TYLIN INTERNATIONAL
The stamped documents are hereby:
Approved as noted
Reviewed and resubmit
See transmittal for additional information as applicable.

Vermont Agency of Transportation
RECEIVED
CK'D BY TYLIN OK'D BY KMH
September 14, 2016
RESUBMIT No Approved AsNoted
BY Kristin Higgins DATE 09/14/2016

VT 100 Road Culvert
Duxbury, Vermont
Culvert Layout - Plan and Elevation

DWG NO.
S1.0

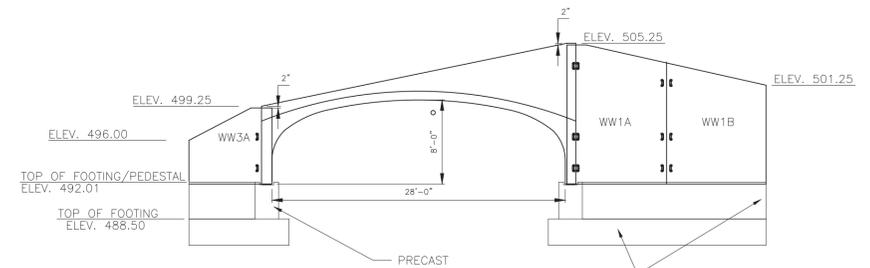
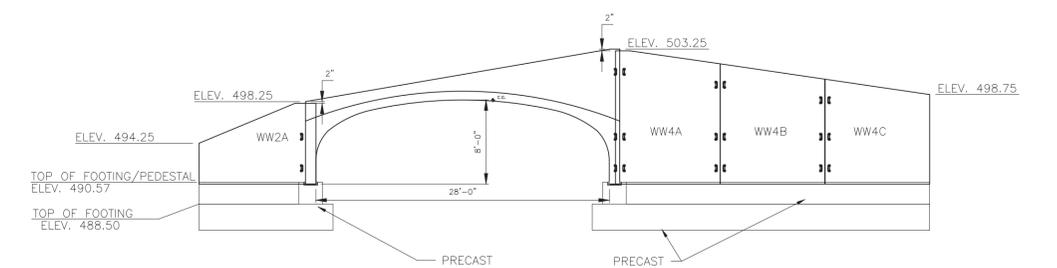
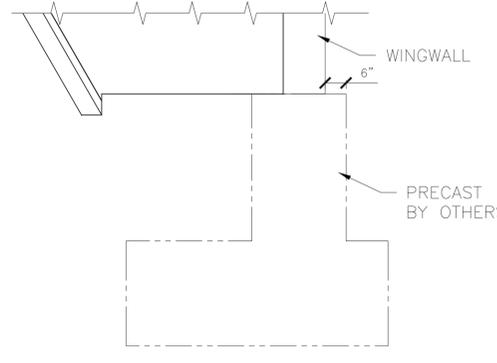
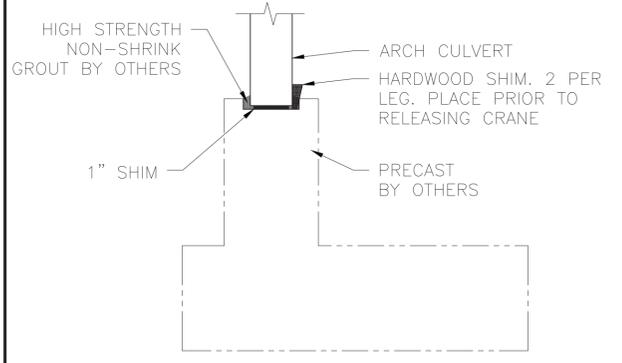
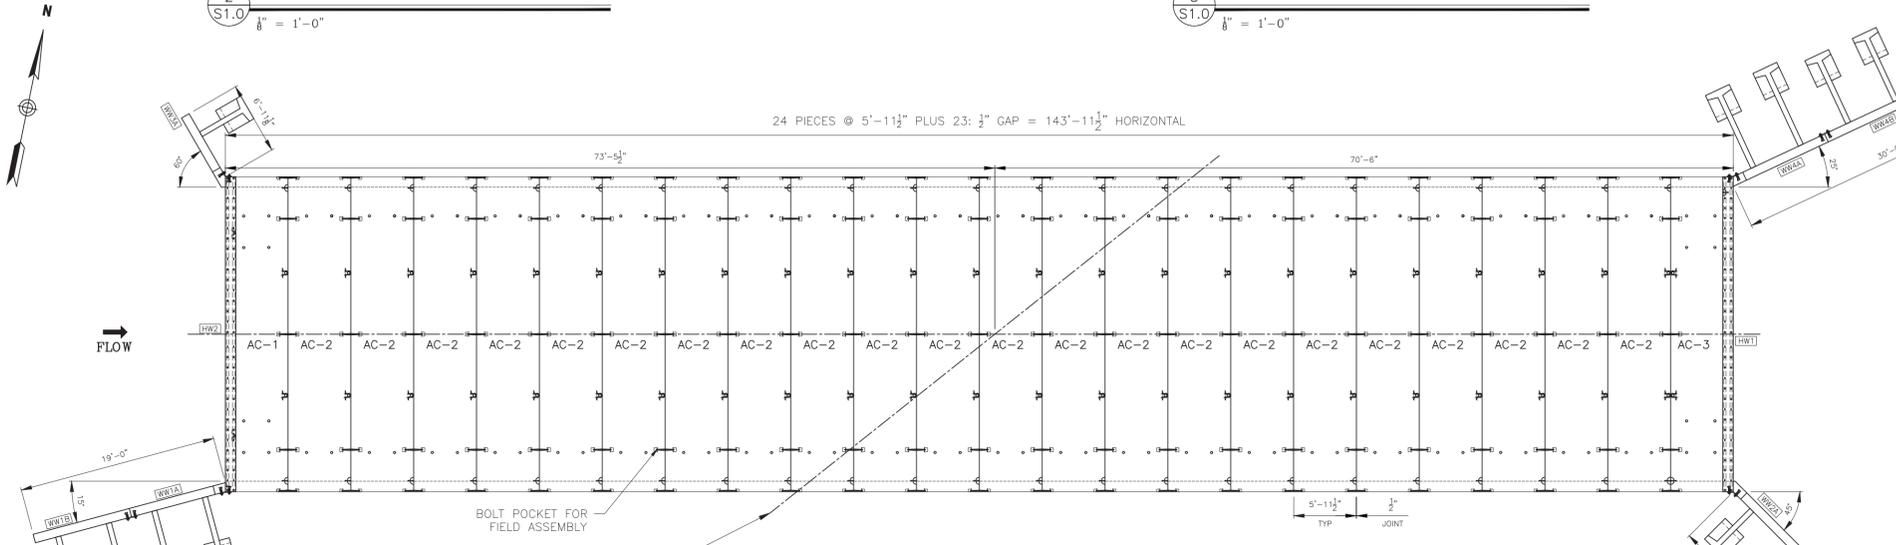
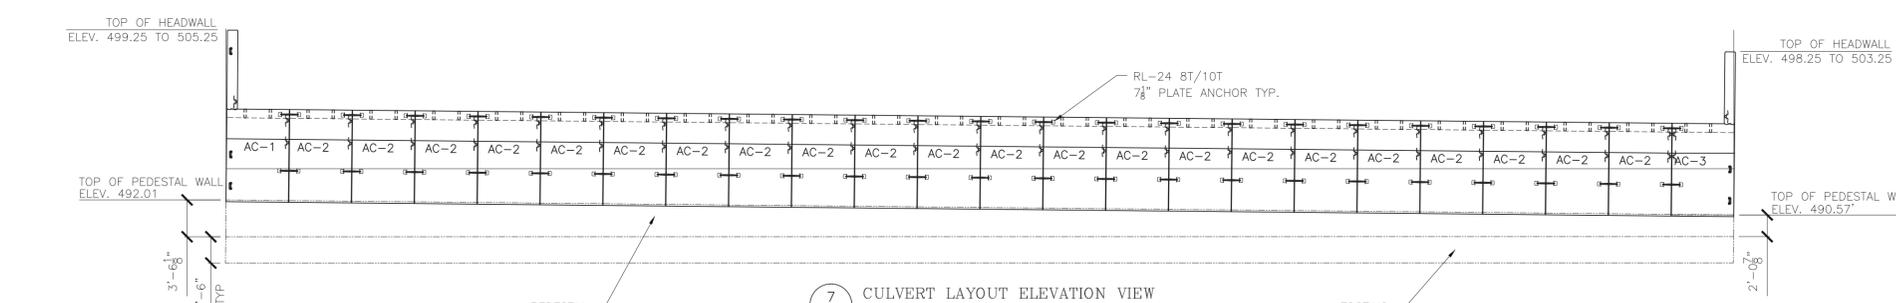
Design of lifting attachments in accordance with Subsections 540.04(h) and 105 is outstanding at this time. However, fabrication in accordance with these plans may proceed at the Fabricator's option with future submittal of the lifting device calculations.
